P-87-237

**NATOMAS CORPORATE CENTER
SACRAMENTO, CALIFORNIA**

REVISED SCHEMATIC PLAN

CREEKSIDE OAKS
 AN OFFICE PARK BY KCS DEVELOPMENT

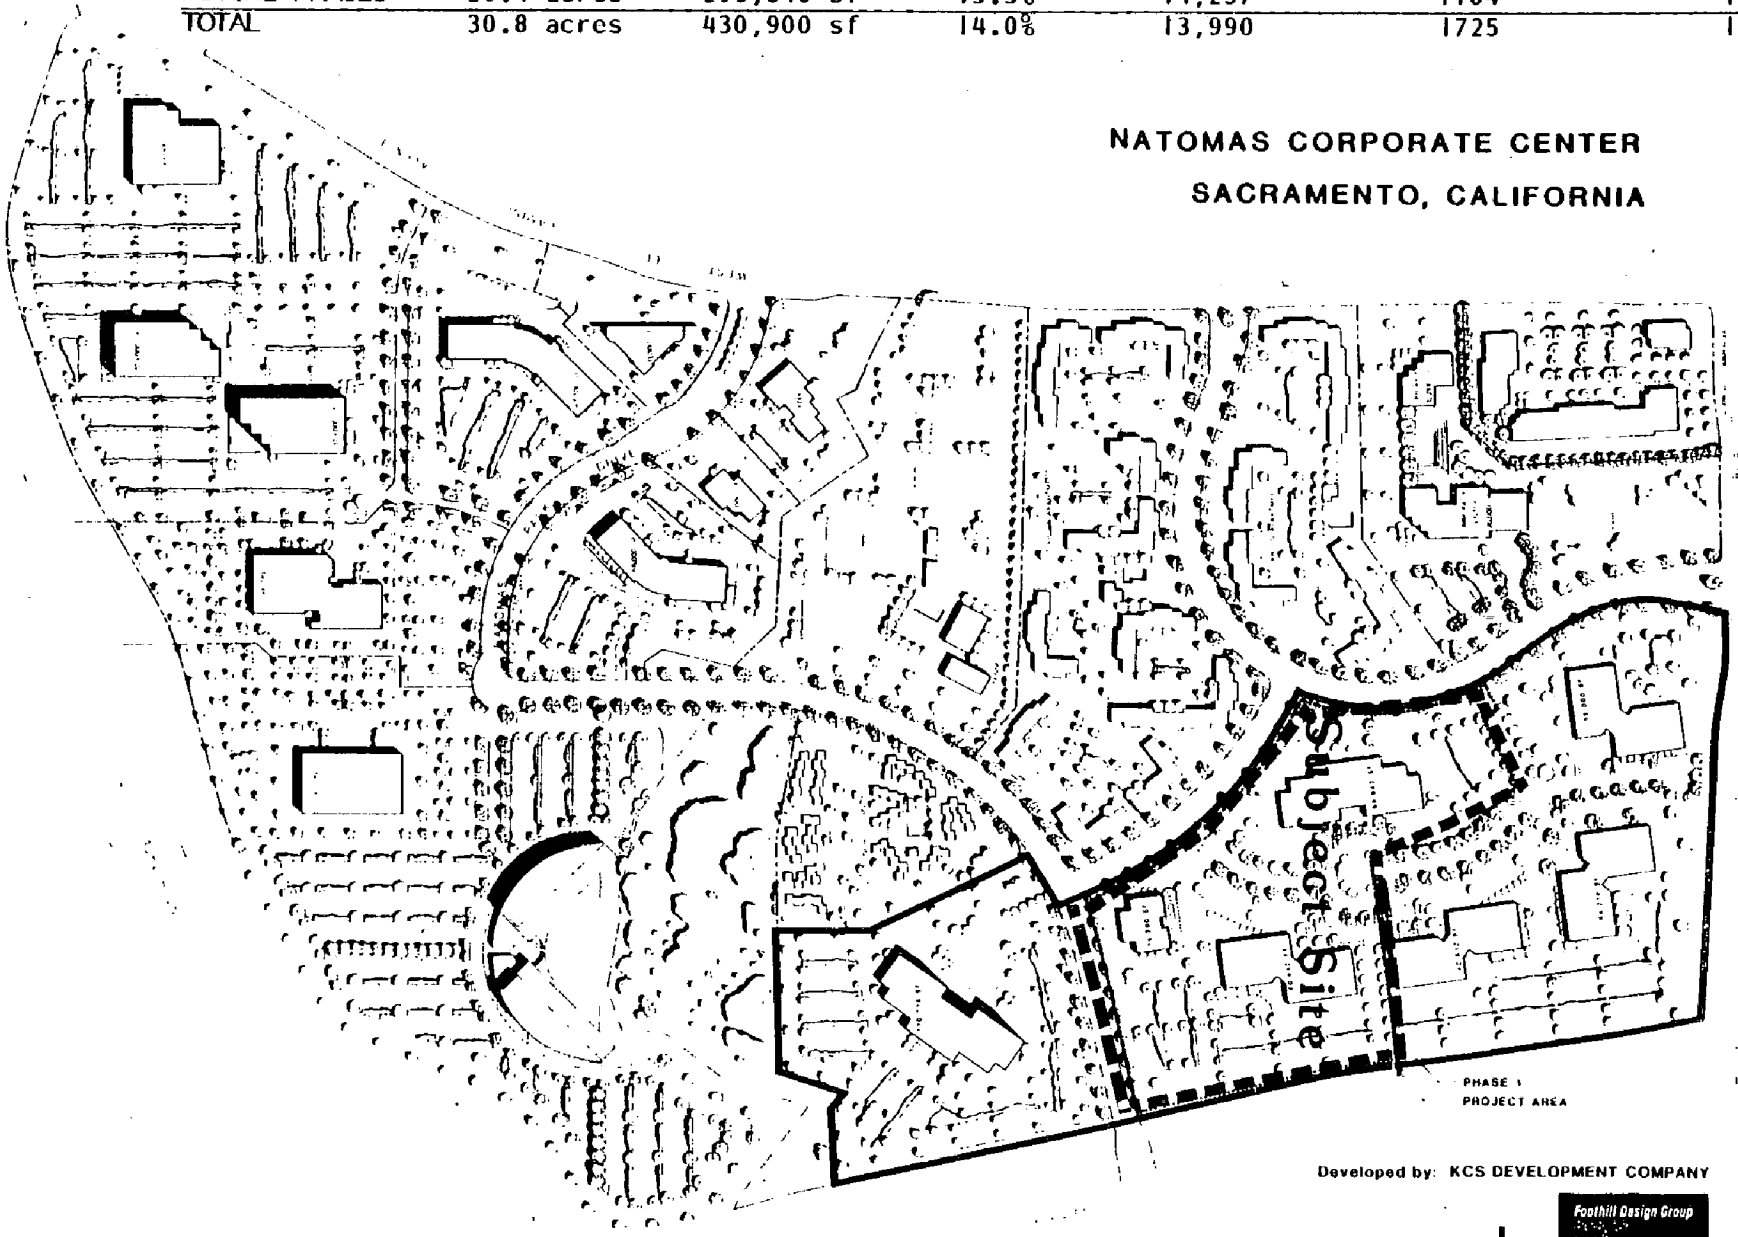
1. Remove islands on divided driveways.
2. Driveways will be a minimum of 24' and a maximum of 35'.
3. Property lines will not split driveways.
4. Request that parking in easement be cleared through Reclamation District.

5. Complete main circulation isle from Capital Park Drive to Mill Creek Drive.
6. A Transportation Management Plan is required for this major project prior to the issuance of building permit.

10. Encroachment into the 15' RD-1000 easement by the parking or other lighting or landscaping must not preclude the development of the City's plans to develop an off-street bike path along the toe of the Garden Highway Levee between Truxel Road and the Bannon Creek Slough Bikeway (see the attached sketch, Exhibit L). The Creekside Oaks PUD guidelines and the Sacramento Bikeways masterplan call for this type of facility to provide a safe route for commuters to downtown through Discovery Park and recreational cyclists accessing the park from South and North Natomas.

15. The applicant shall prepare a revised site plan showing loading areas; parking lot redesign to show no more than ten consecutive spaces and then a tree planter finger; all concerns of the City Traffic Engineer shall be reflected on the revised site plan.
